Subject:	Site Plan Review: Rines Forest Parking Lot – Range Road
From	Carla Nixon, Planning Director
То	Town of Cumberland Planning Board
Date	October 13, 2021

**Project:** Rines Forest Parking Lot

Subject: Peer Review

Subject:	Rines Forest Parking Lot
	Town of Cumberland Site Plan Review Application
	Response to Peer Review Comment dated September 13, 2021.

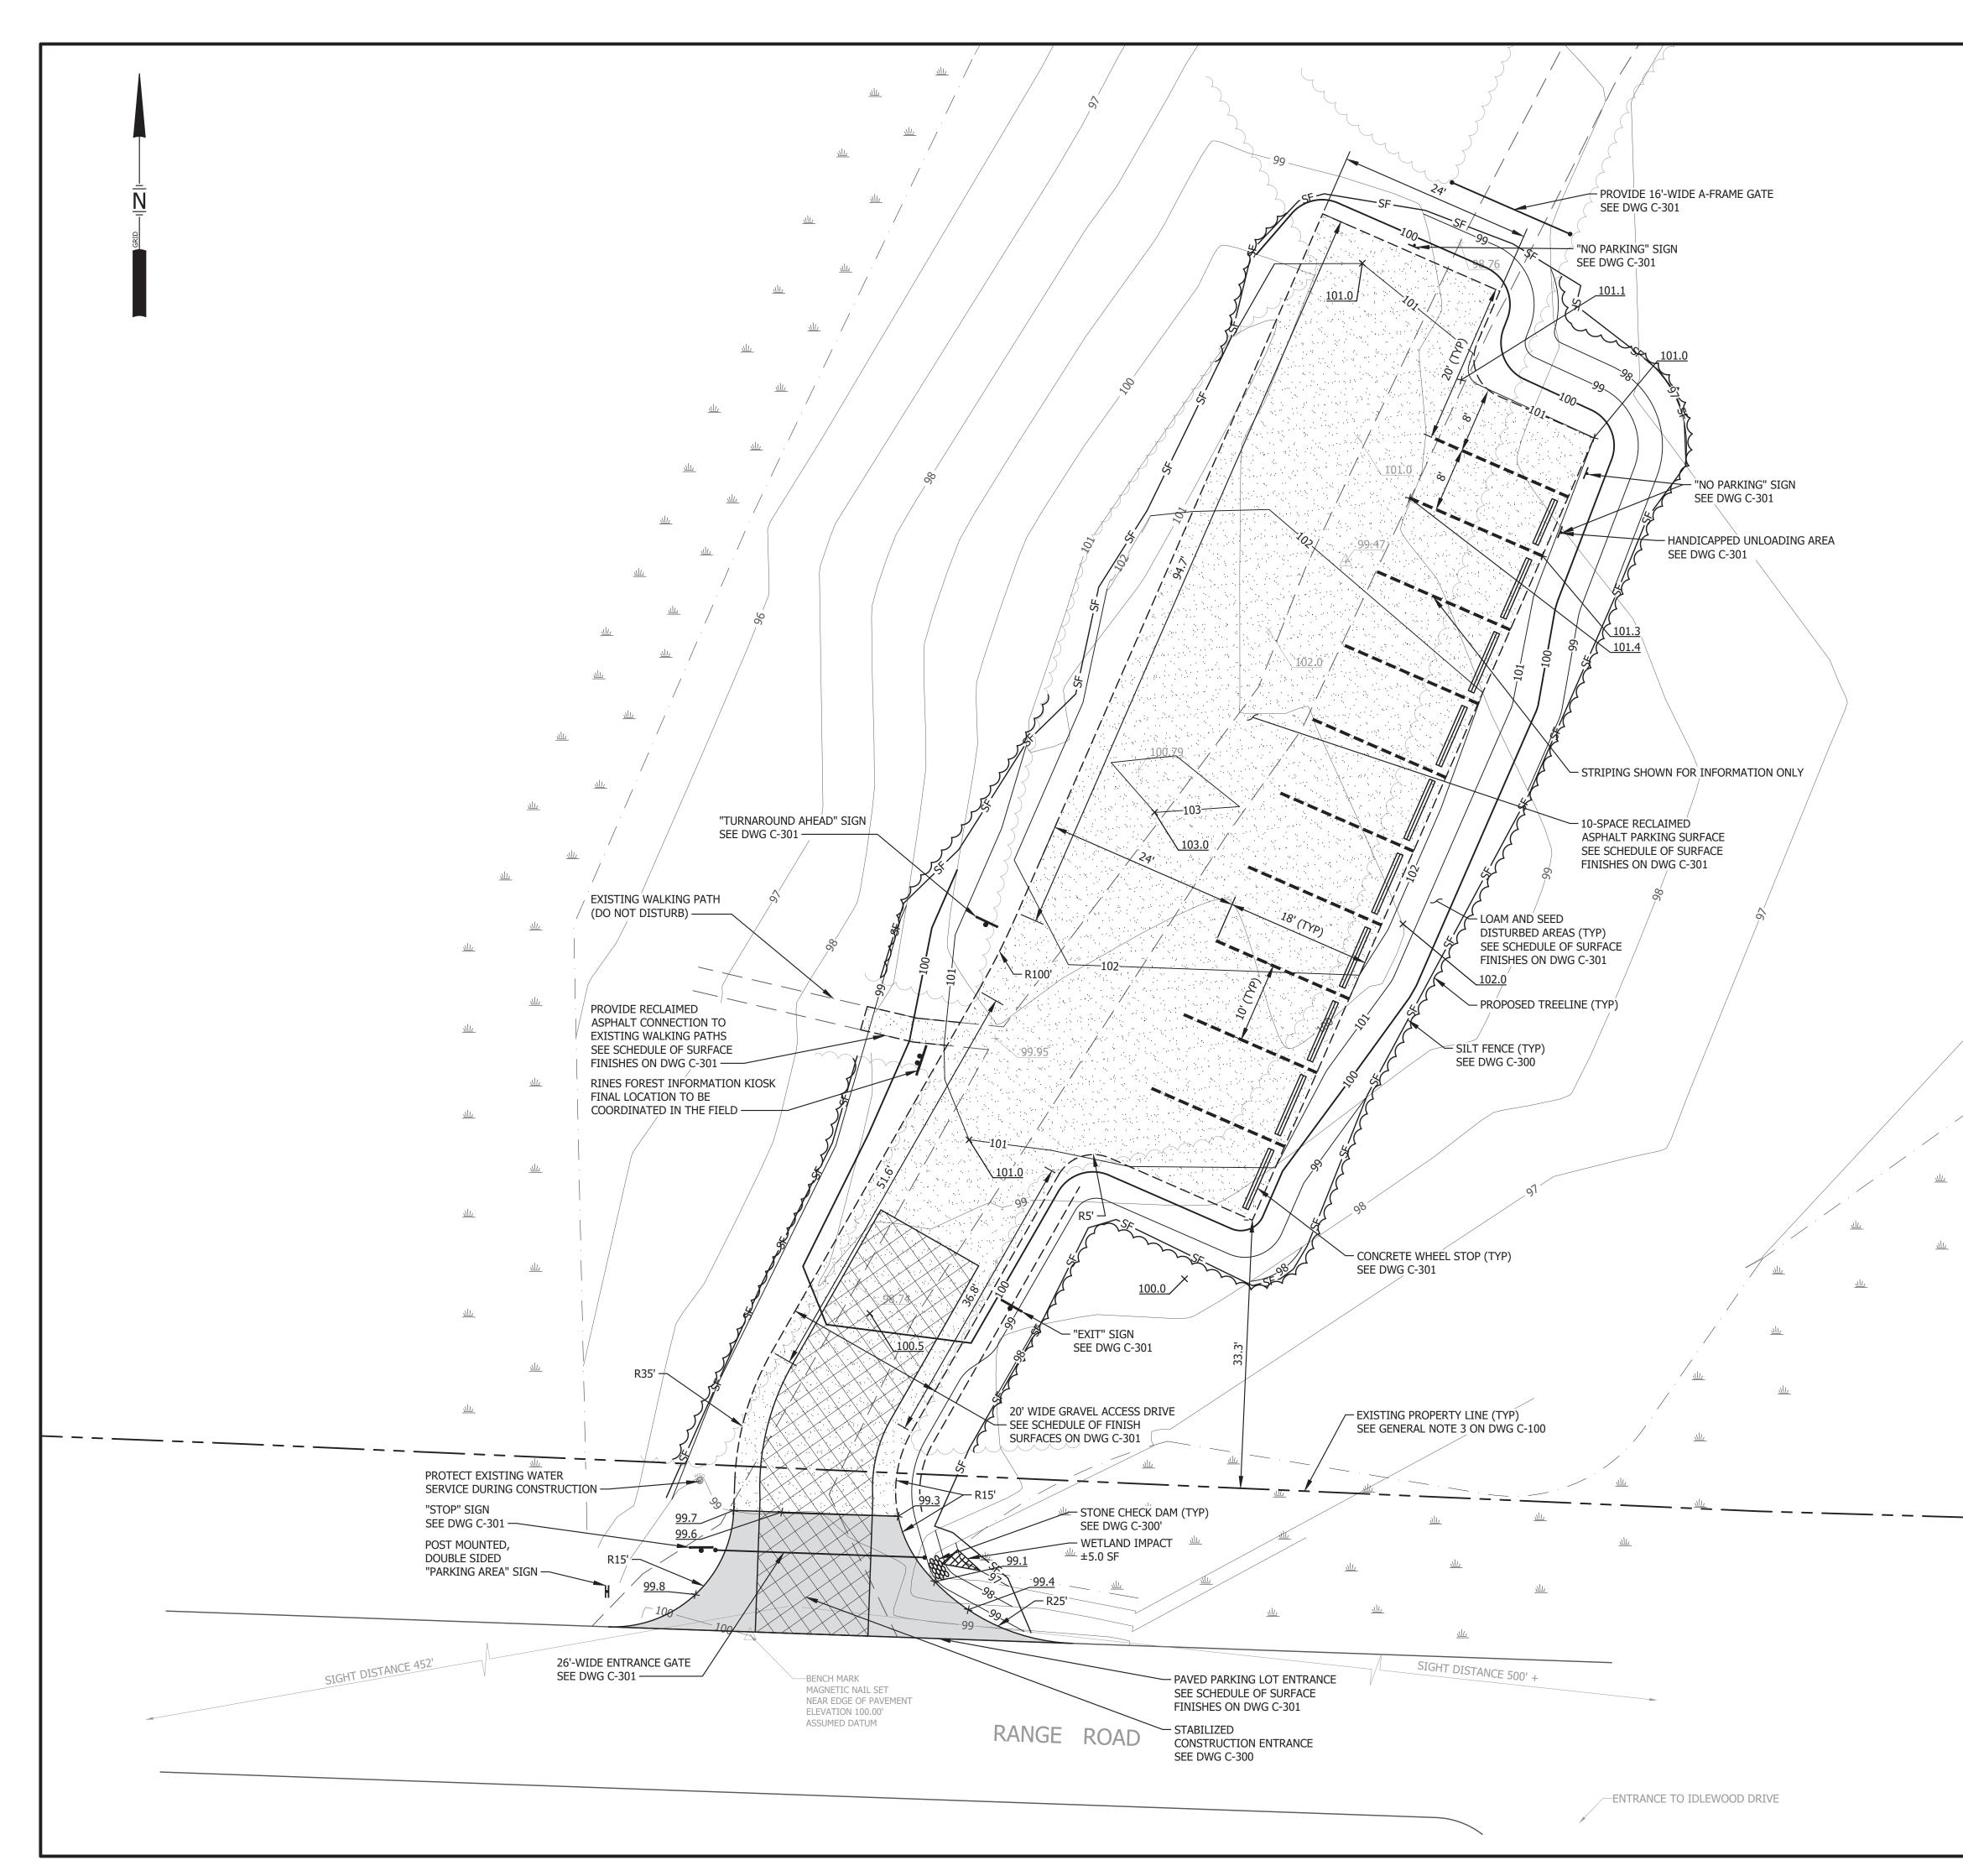
- 3. It would appear that one accessible parking space is required and must be van accessible. A van accessible space and access aisle need to be a total of 16 feet wide. Revise layout to show accessible space.

- 6. Provide spot grades at the accessible space with a maximum of 2% slope in all directions.
- 7. Provide a gate detail.
- 8. The proposed gate is approximately 30' from Range Road and may not be visible for drivers approaching from the east. This could result in a user entering the site, encountering the gate, and then needing to back up onto Range Road. If the gate were relocated to the edge of the right of way, would it be more visible and potentially reduce the need for users to back out onto Range Road, while still allowing a vehicle to park between the gate and Range Road for opening/closing purposes.

- 9. Provide sign construction details.
- 10. Provide additional spot grades along the entrance drive from Range Road to the proposed 100' contour. Range road is at an elevation of approximately 100', so more definition of the grading is needed to ensure that a low point is introduced within the paved apron off the edge of pavement for Range Road.

It would appear that one accessible parking space is required and must be van accessible. A van accessible space and access aisle need to be a total of 16 feet wide. Revise layout to show accessible space.

#### Provide spot grades at the accessible space with a maximum of 2% slope in all directions.

Provide additional spot grades along the entrance drive from Range Road to the proposed 100' contour. Range road is at an elevation of approximately 100', so more definition of the grading is needed to ensure that a low point is introduced within the paved apron off the edge of pavement for Range Road.

<u>SME Response</u>: A handicap parking space has been added to the northern corner of the lot with an adjacent 8-foot-wide loading area.

<u>SME Response</u>: Spot grades have been added at the accessible space to show maximum of 2% slope as shown on C-102.

<u>SME Response</u>: The gate has been moved to be 10' from the Range Road as shown in C-102.

<u>SME Response</u>: Additional spot grades have been added to C-102 to provide defined grading to ensure a low point is introduce within the paved apron.

BAR GATE DETAIL

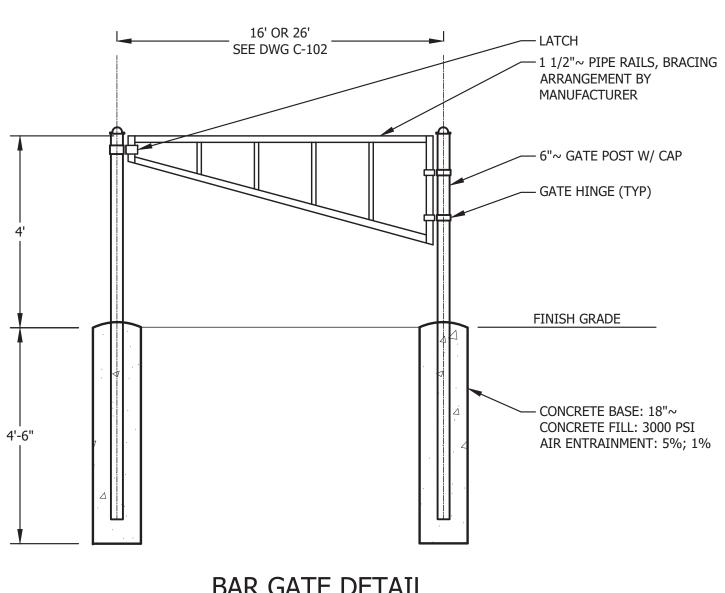
- 11. The Wheel Stop Detail on Sheet C-301 indicates either a 6' or 8' wheel stop. Based on the Site Plan, the wheel stop appears to be 8' in length. Please clarify.

## The Wheel Stop Detail on Sheet C-301 indicates either a 6' or 8' wheel stop. Based on the Site Plan, the wheel stop appears to be 8' in length. Please clarify.

SME Response: A gate detail has been provided on C-301.

SME Response: The sign details have been provided in C-301.

<u>SME Response</u>: The Wheel Stop should be 8' in length for the 9 by 18 parking spaces and a 6' long for the handicapped parking space. The detail on Drawing C-301 was updated to reflect this.
